## Department of Energy

September 3, 2004

**Program Plan for Analysis of Shear Wave Velocity Data to Address Uncertainties in  
Estimates of Hanford Ground Motion Waste Treatment Project**

August 27, 2004

Figure 1. Location of Geologic Profile (on next page) from the IDF site through the WTP site.

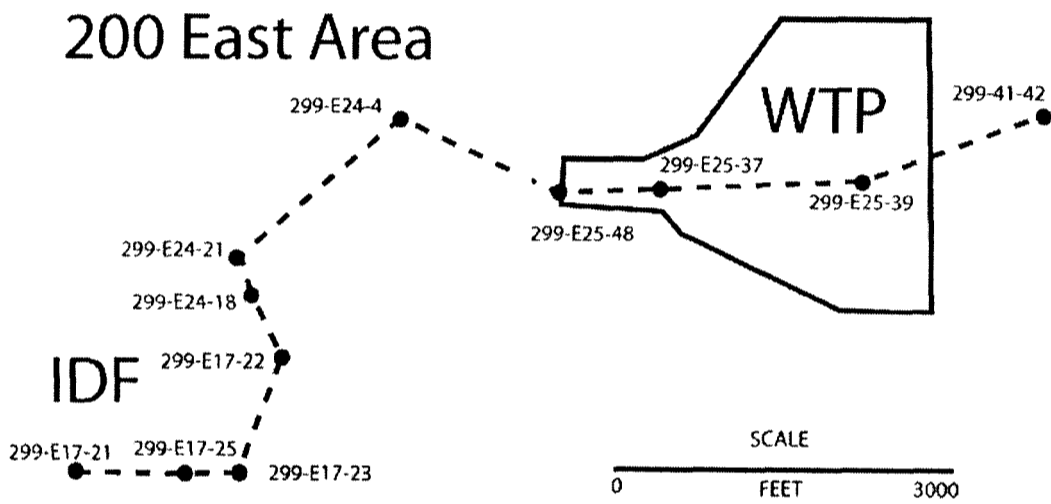
**Issue #1:** *Comparison of the geology and the intervening paleo-channel between the Integrated Disposal Facility (IDF) site and the WTP site; the overall thickness of soil (depth to bedrock); the thickness of individual soil layers (Hanford and Ringold formations);  $V_s$  for all layers (soil, basalt bedrock, sedimentary interbeds); and potential lateral variation in  $V_s$ .*

The detailed supra-basalt (sediment above the basalt) geology in the area surrounding and within the WTP site will be assembled and presented, using data from numerous boreholes that have been drilled and logged as part of the IDF site (adjacent to WTP) and other previous studies in the nearby area (see Figure 1). These data provide the thickness of each individual soil layer in the Hanford and Ringold formations, and depth to basalt bedrock, at numerous geographic locations surrounding and within the WTP site. Lateral variations in some of the lower sedimentary layers (Ringold formation), such as the paleo-channel that lies between the IDF site and the WTP site are known, but the sedimentary structures outside of this erosional channel are the same as those at the IDF and WTP sites, and addition to other nearby locations outside of this erosional channel. The paleo-channel does not affect the structure within the basalt sequence (see Figure 2).
